**STAFF REPORT**  
**Proposed Veranda Master Plan and Subdivision**

FILE NUMBER: SD/MIS 20-26000343 (MPLAN 21-00652)

PROPOSAL: To establish an applicant-initiated Pleasant Valley Master Plan and 187-lot subdivision (revised to 169 lots) for an approximately 38.9-acre area. All existing improvements on the site will be removed and the current well and onsite septic system will be decommissioned.

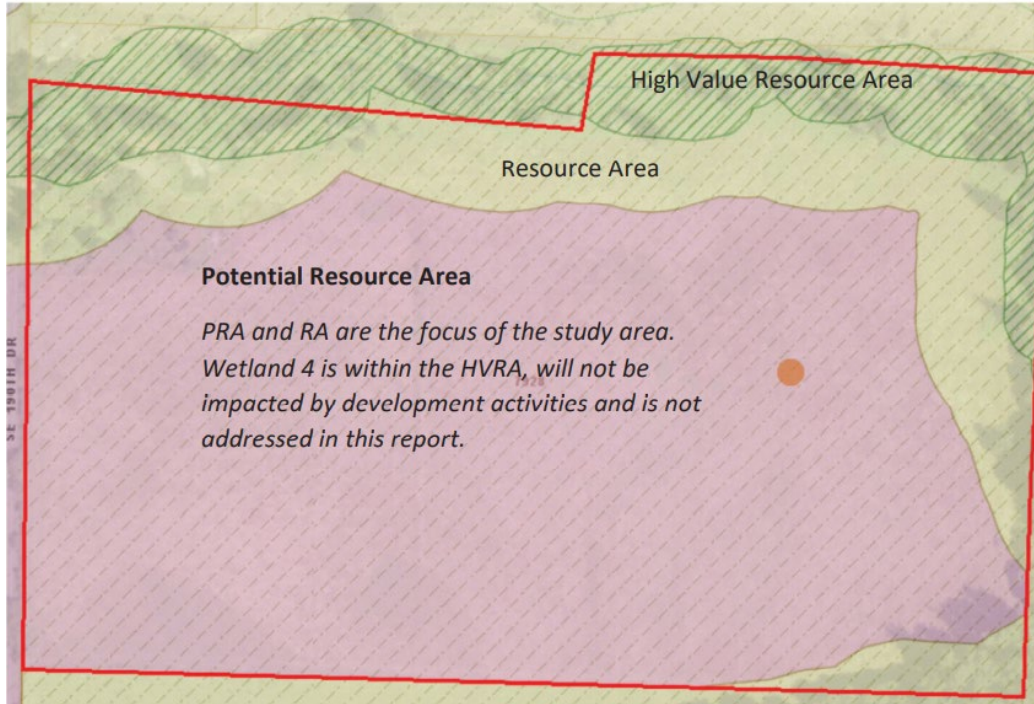
The application does not provide review of avoided or minimized and mitigated environmental impacts within the ESRA-PV abutting the 190<sup>th</sup> Ave right-of-way at the Kelly Creek crossing.

There are proposed water, wastewater, and stormwater scenarios that suggest there would be impacts within the ESRA-PV here. We have inadequate information to assess whether those impacts would be in conflict with environmental protections for the area, or how they would mitigate for approvable impacts.

A complete mapping of all streams, wetlands, and other water bodies throughout the parcel and on adjacent parcels is required by the 2020 ESRA-PV code.

The environmental reporting submitted to DSL for the re-delineation states there will be no impacts with the Veranda development within the "HVRA/RA" area, yet there are portions of proposed tax lots and a roadway within the RA (riparian) buffer (again, RA buffers should not be used as this was submitted under ESRA-PV era), as well as stormwater treatment and/or conveyance elements presumably in this area. Thus, the information provided to DSL does not appear to be consistent with the applicant's proposed road and tax lot layout.
